REQUEST FOR PROPOSAL

Questions and Answers

VoIP Telephone System Replacement
For
South San Joaquin Irrigation District

VoIP Telephone System Replacement RFP – Questions and Answers

- District Office, Building A: Cat 5e. cabling. Only yellow and blue cables will need patch panel. Approx. 45.

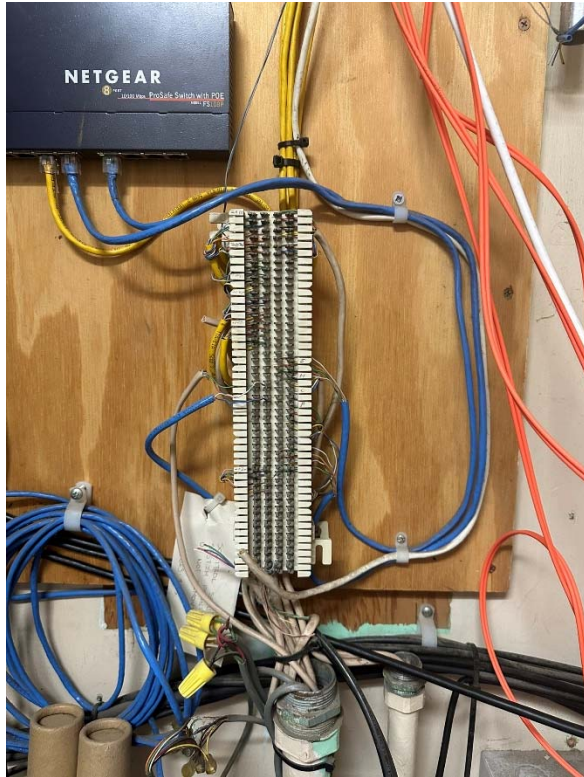
- Replacing punch down blocks with patch panels sound relatively easy enough. However, we don't know how many ports are required for the new patch panel. Do the existing cables have enough wiggle room to be moved from 66 Blocks to Panel? Is the panel to be wall mounted or is it going into a data rack/cabinet?
 - Please see the pictures for reference:
